ADDENDUM #2 – APRIL 18, 2024

RE: SOUTH COAST EDUCATIONAL SERVICE DISTRICT
Attic Restoration
Project #23.61.2

FROM: HGE ARCHITECTS, Inc.
333 South 4th Street
Coos Bay, Oregon 97420
541-269-1166

A2.2

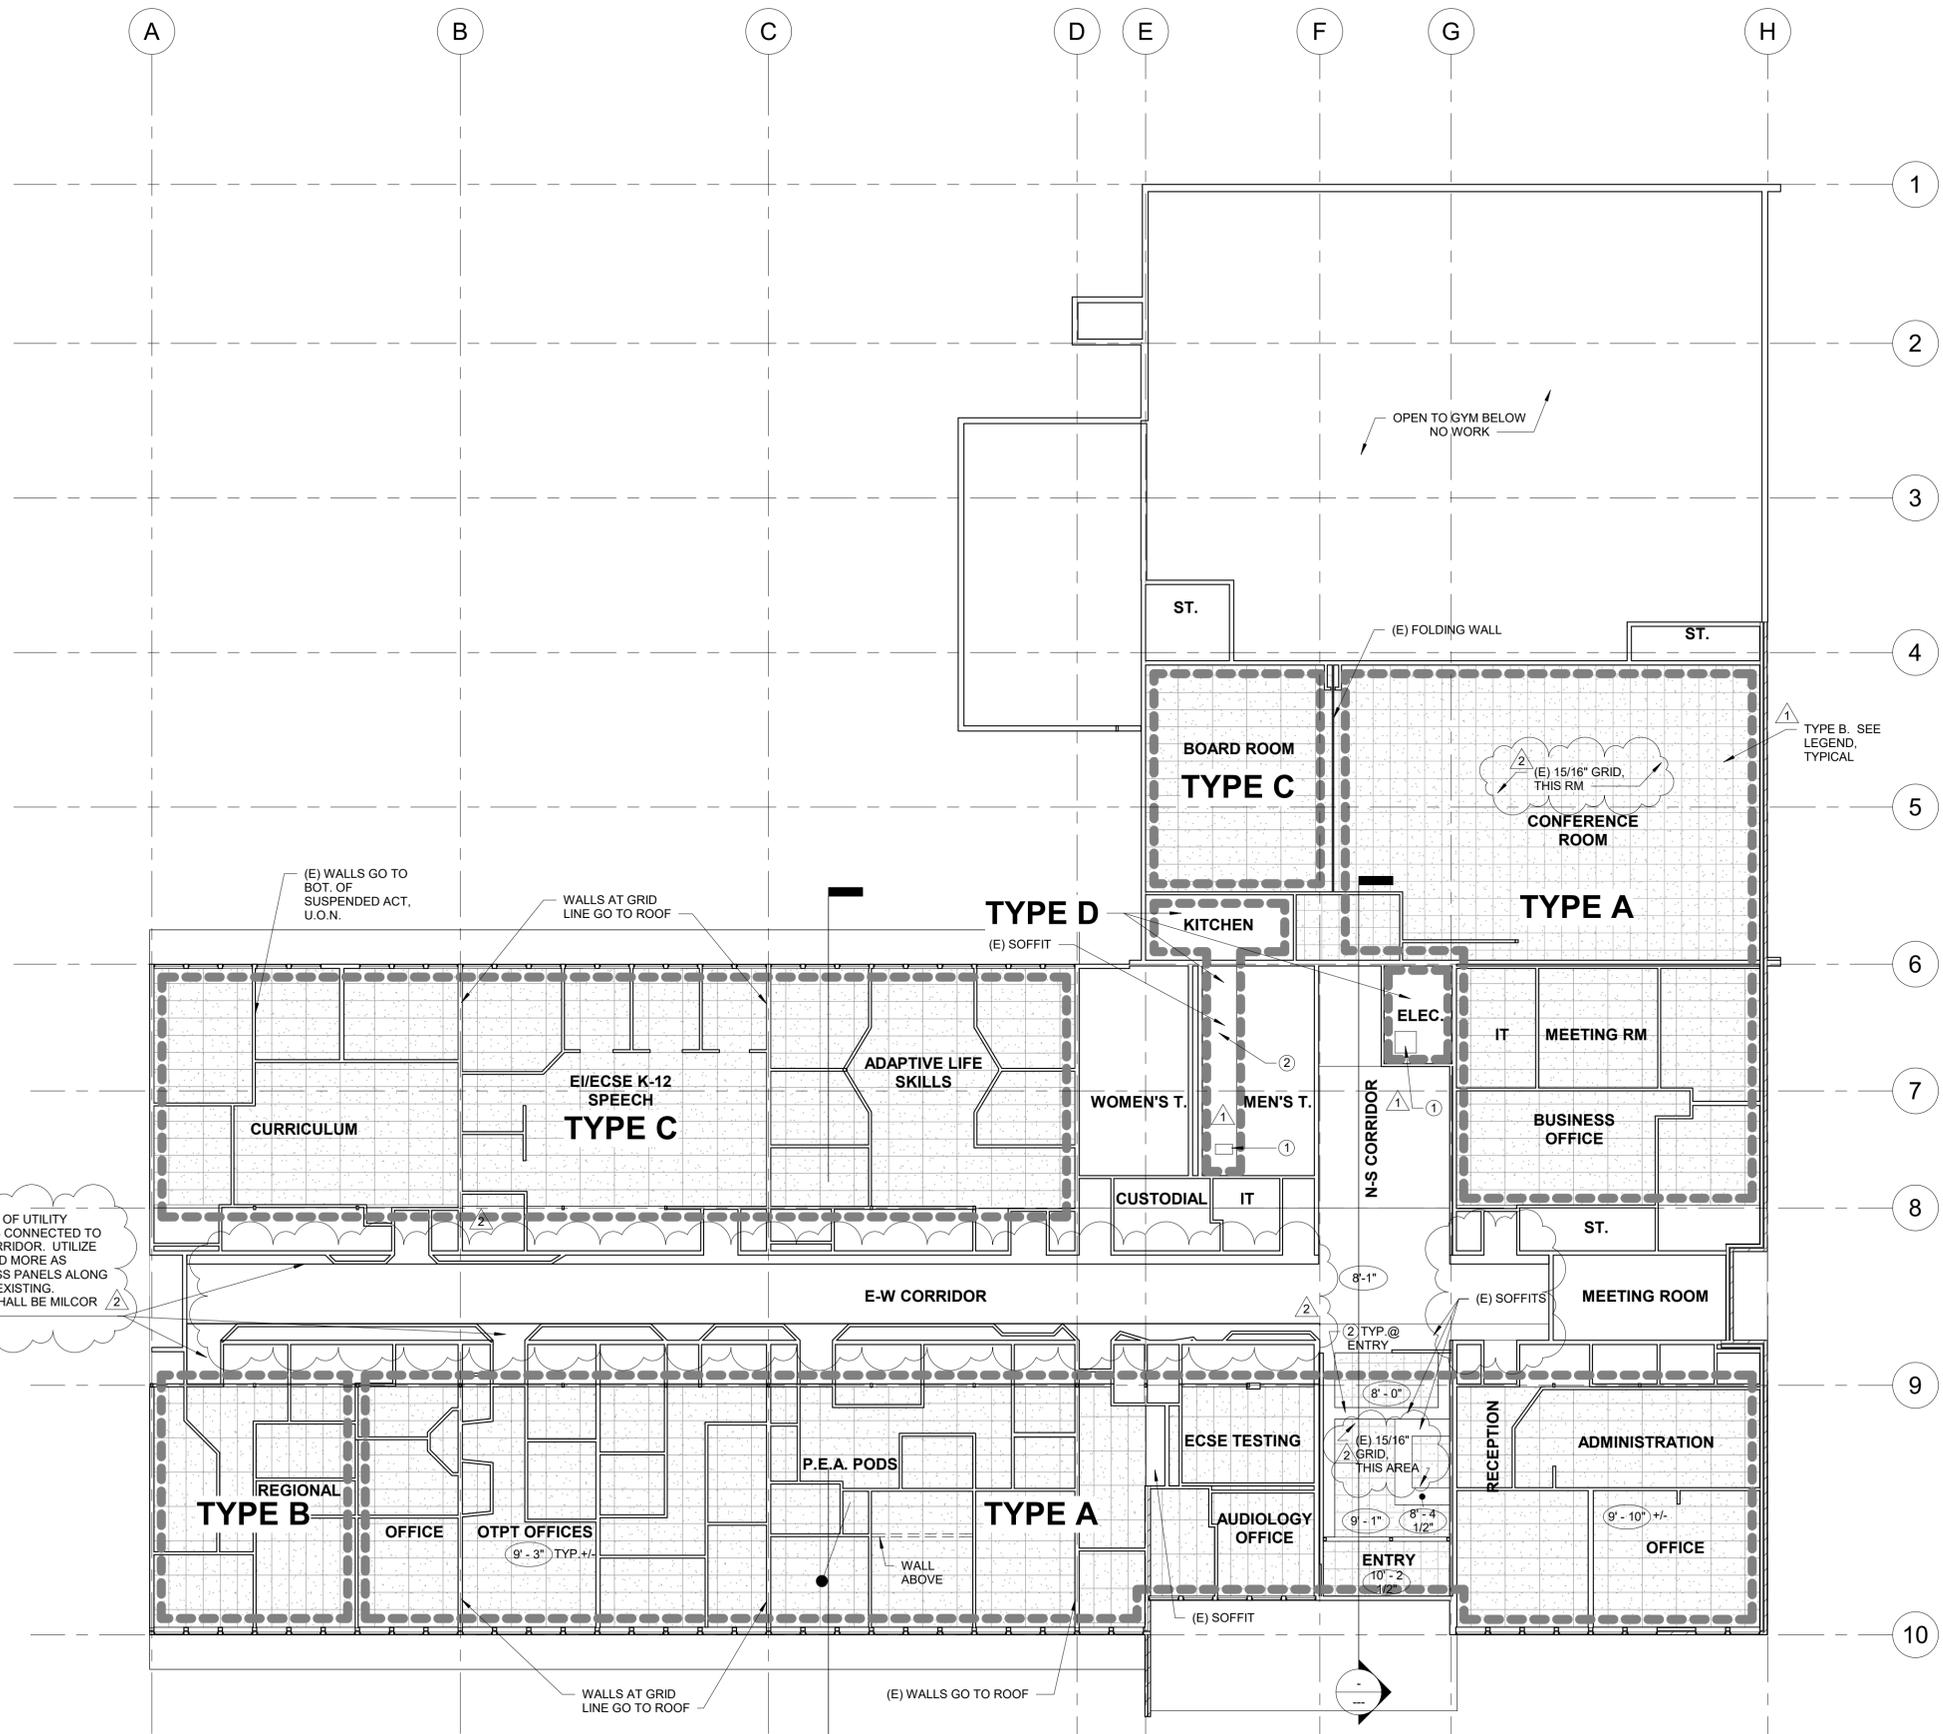
- 1. Sheet A2.1 Main Floor Plan / Phasing:** ADD General Note "10. TAPE OFF (E) VENTS WITHIN THE AREA OF WORK. PROVIDE SUPPLY AND EXHAUST AIR TO THE AREA OF WORK."
- 2. Sheet A2.2 Main Floor Reflected Ceiling Plan:** Summary of changes:
 - a.** ADD to RCP NOTES: "E. ALL EXISTING CEILING SUSPENSION GRID IS TO REMAIN. THE GRID HAS A 5/16" FACE WIDTH TYPICALLY - U.O.N."
 - b.** ADD note "(E) 15/16" GRID, THIS RM" in the Conference Room.
 - c.** ADD note "(E) 15/16" GRID, THIS AREA" in the Entry
 - d.** ADD Keynote "2, TYP. @ ENTRY"

- e. ADD note pointing to raceways in Corridor and adjacent ceilings: "VACUUM RODENT DEBRIS OUT OF UTILITY RACEWAYS, AND ALL CEILINGS CONNECTED TO THEM, ENTIRE LENGTH OF CORRIDOR. UTILIZE EXISTING ACCESS PANELS. ADD MORE AS REQUIRED. ADDITIONAL ACCESS PANELS ALONG THE RACEWAY SHALL MATCH EXISTING. ACCESS PANELS AT CEILING SHALL BE MILCOR M, WITH GASKET, OR EQUAL."
3. **Sheet A3.2 Enlarged Sections:** REPLACE with attached REVISED sheet. Summary of changes:
- a. Add "Raceway" Soffits to sections and note "VACUUM RODENT DEBRIS OUT OF UTILITY RACEWAYS, AND ALL CEILINGS CONNECTED TO THEM, ENTIRE LENGTH OF CORRIDOR. UTILIZE EXISTING ACCESS PANELS. ADD MORE AS REQUIRED. ADDITIONAL ACCESS PANELS ALONG THE RACEWAY SHALL MATCH EXISTING. ACCESS PANELS AT CEILING SHALL BE MILCOR M, WITH GASKET, OR EQUAL."
